# ***Wetherill Park Waste Transfer Station***

*State Significant  
Development  
Modification Assessment  
(SSD 7267 MOD 2)*

April 2019

Figure 3 | Staging Plan

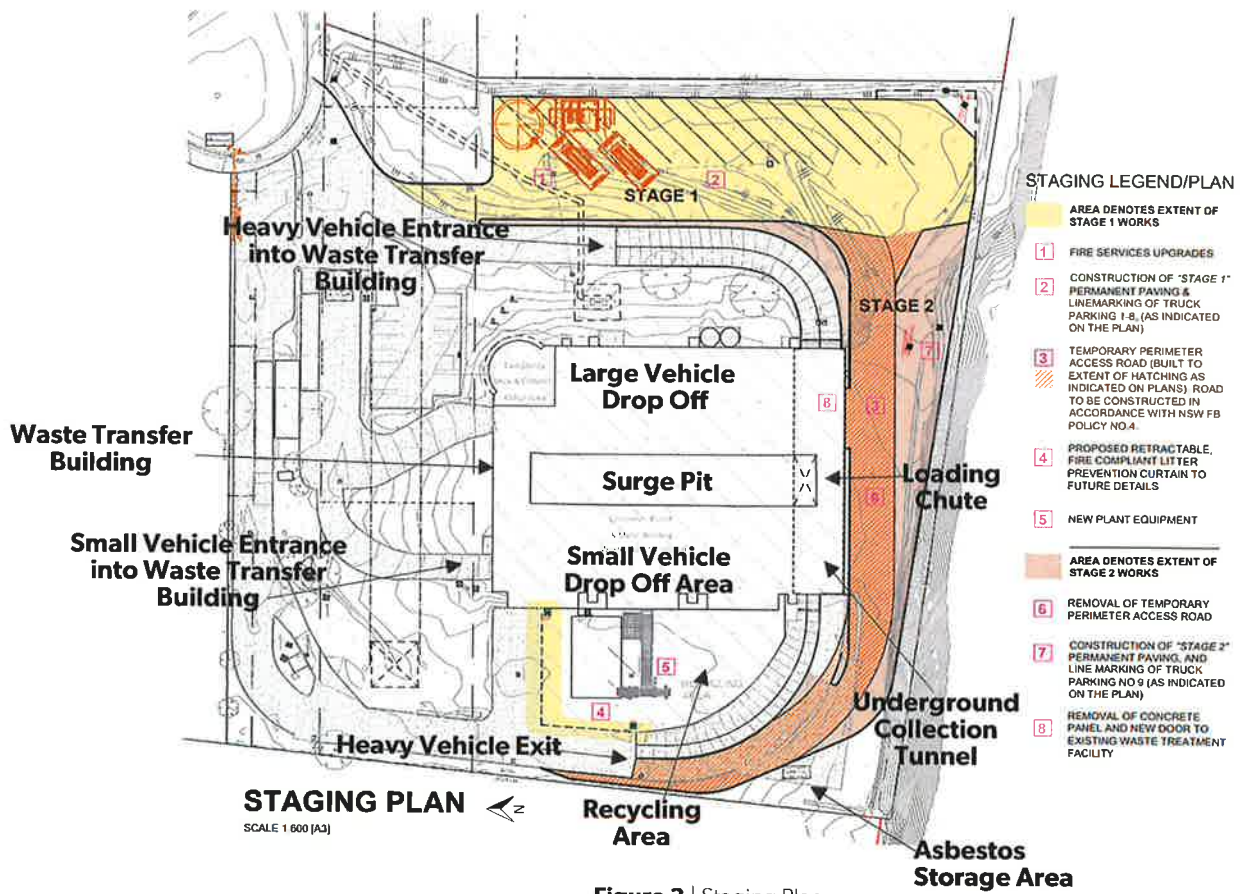
- The asbestos storage area may impact vehicle maneuverability on the proposed temporary access road and the permanent access ring road.
- The Department noted the proposed temporary access road and the permanent access ring road would require part of the area allocated for the storage of asbestos waste located on the south-western corner of the site (see **Figure 3** and **Figure 4**).

- The Department was concerned there wouldn't be enough space for the Applicant to store the weekly limit of up to 10m<sup>3</sup> of asbestos waste in the three to four skip bins the Applicant currently uses to store the asbestos waste and the asbestos storage area may impact vehicle maneuverability on the temporary and permanent access road.

- The Applicant noted:
  - the ring road would not be used regularly by heavy vehicles as it is not a main thoroughfare
  - only two skip bins are required to store 10m<sup>3</sup> of asbestos waste weekly. One skip bin can hold up to approximately 19 m<sup>3</sup> of waste.

- the skip bins would be stored in tandem not side by side therefore requiring less space
  - asbestos waste is only accepted at the site on weekends ensuring minimal access to the area

- asbestos waste is transported off-site once a week.
- The Department is satisfied the Applicant would be able to maintain the asbestos storage area in its current location and vehicles would be able to maneuver in the area without being hindered. The Applicant has proposed to reduce the number of skip bins stored in the area to two skip bins, which can store approximately 4 weeks of the sites permitted asbestos intake.

- The Department has recommended a condition requiring the Applicant ensure the asbestos storage area is maintained so as to not impact vehicle maneuverability on the temporary access road and the permanent ring road.
